**SUBJECT: THREE MILE ISLAND, UNIT 1 (TMI UNIT 1)  
OPERATING LICENSE No. DPR-50  
DOCKET No. 50-289  
LICENSE AMENDMENT REQUEST NO. 303 -  
PRESSURE-TEMPERATURE PROTECTIVE LIMITS**

**TMI Unit 1 License Amendment Request No. 303**

**Safety Evaluation and No Significant Hazards Consideration**

**Affected TMI Unit 1 Technical Specification Pages**

Figure 2.1-1

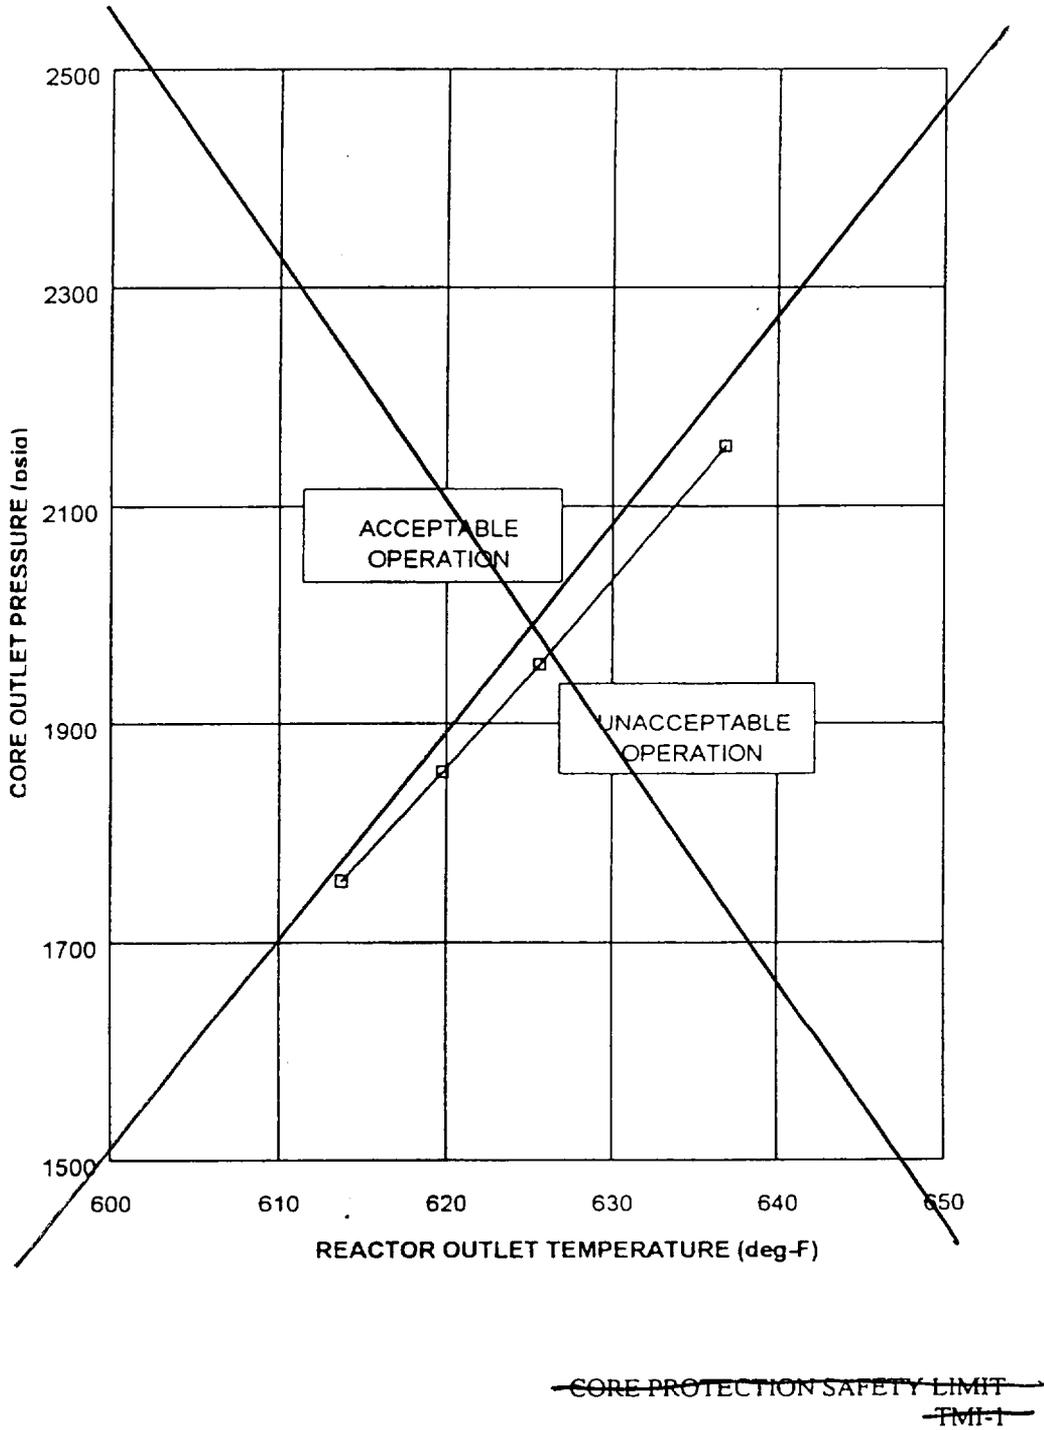
2.1.1 The combination of the reactor system pressure and coolant temperature shall not exceed the safety limit as defined by the locus of points established in ~~Figure 2.1.1~~. If the actual pressure/temperature point is below and to the right of the line, the safety limit is exceeded.

*Variable Low RCS Pressure-Temperature Core Protection Safety Limit curves presented in the*  
 The ~~curve presented in Figure 2.1.1 represents~~ the conditions at which the COLR represents minimum allowable DNBR or greater is predicted for the limiting combination of thermal power and number of operating reactor coolant pumps. *These curves are* based on the nuclear power peaking factors given in Reference 3 and the COLR which define the reference design peaking condition in the core for operation at the maximum overpower. Once the reference peaking condition and the associated thermal-hydraulic situation has been established for the hot channel, then all other combinations of axial flux shapes and their accompanying radials must result in a condition which will not violate the previously established design criteria on DNBR. The flux shapes examined include a wide range of positive and negative offset for steady state and transient conditions.

The ~~curve of Figure 2.1.1~~ is the most restrictive of all possible reactor coolant pump-maximum thermal power combinations ~~shown in Figure 2.1.3~~. The ~~curves of Figure 2.1.3~~ represent the conditions at which the DNBR limit is predicted at the maximum possible thermal power for the number of reactor coolant pumps in operation or the local quality at the point of minimum DNBR is equal to 22 percent, (BAW-2), or 26 percent (BWC) whichever condition is more restrictive.

**DELETED**

*the Variable Low RCS Pressure - Temperature Core Protection Safety Limits as specified in the COLR.*

*Variable Low RCS Pressure-Temperature Core Protection Safety Limit for four reactor coolant pumps operating*

FIGURE 2.1-3

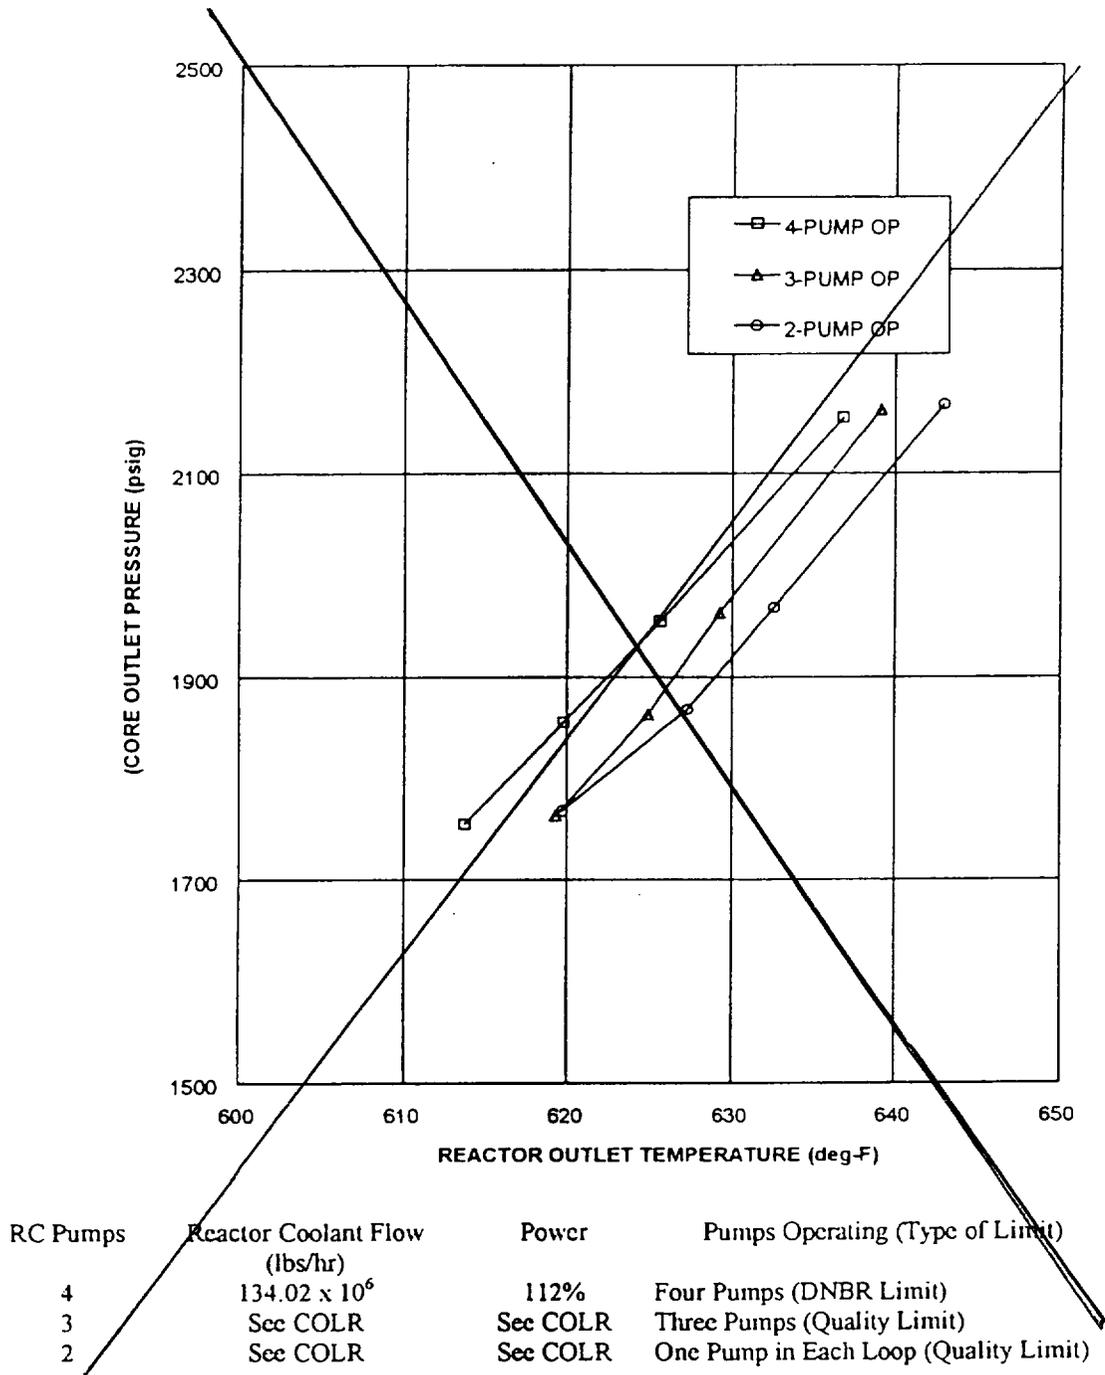
Using a local quality limit of 22 percent (BAW-2), or 26 percent (BWC) at the point of minimum DNBR as a basis for curves 2 and 3 of ~~Figure 2.1.3~~ is a conservative criterion even though the quality at the exit is higher than the quality at the point of minimum DNBR.

For each ~~curve of Figure 2.1.3~~, a pressure-temperature point above and to the left of the curve would result in a DNBR greater than 1.30 (BAW-2) or 1.18 (BWC) or a local quality at the point of minimum DNBR less than 22 percent (BAW-2), or 26 percent (BWC) for the particular reactor coolant pump ~~situation~~. ~~Curve 1~~ is more restrictive than any other reactor coolant pump ~~situation~~ because any pressure/temperature point above and to the left of this curve will be above and to the left of the other curves.

**DELETED**

~~CORE PROTECTION SAFETY BASES~~  
~~TMI-1~~

*combination of operating reactor coolant pumps of the Variable Low RCS Pressure-Temperature Core Protection Safety Limits specified in the COLR*

Figure 2.3-1

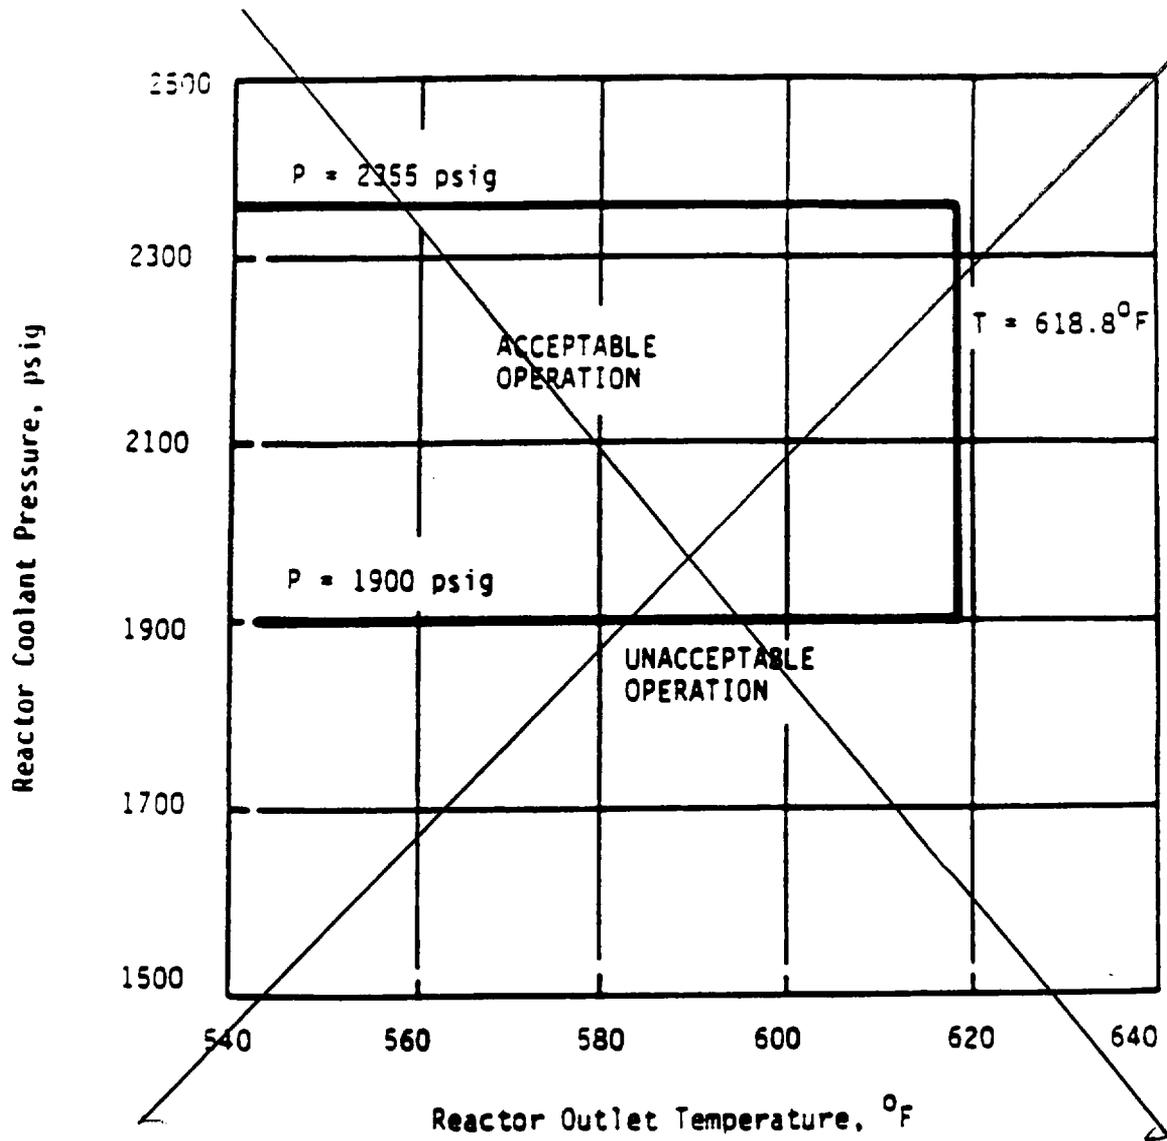
crossflow model <sup>can</sup> resulted in safety limits (see ~~Figures 2.1-1 and 2.1-3~~) outside the acceptable operating region formed by the low pressure, high pressure, and high temperature trip setpoints (see ~~Figure 2.3-1~~) which justifies the removal of the variable low pressure trip *is unnecessary and its removal is justified.*

The high reactor coolant <sup>Table</sup> outlet temperature trip setting limit (618.8F) shown in ~~Figure 2.3-1~~ has been established to prevent excessive core coolant temperature in the operating range.

**DELETED**

~~TMI-1~~  
~~PROTECTION SYSTEM MAXIMUM~~  
~~ALLOWABLE SETPOINTS~~

Variable Low RCS Pressure - Temperature Core Protection Safety Limits specified in the COLR

Specified in RCS  
Pressure-Temperature  
Protective Maximum  
Allowable Setpoints  
Figure in COLR
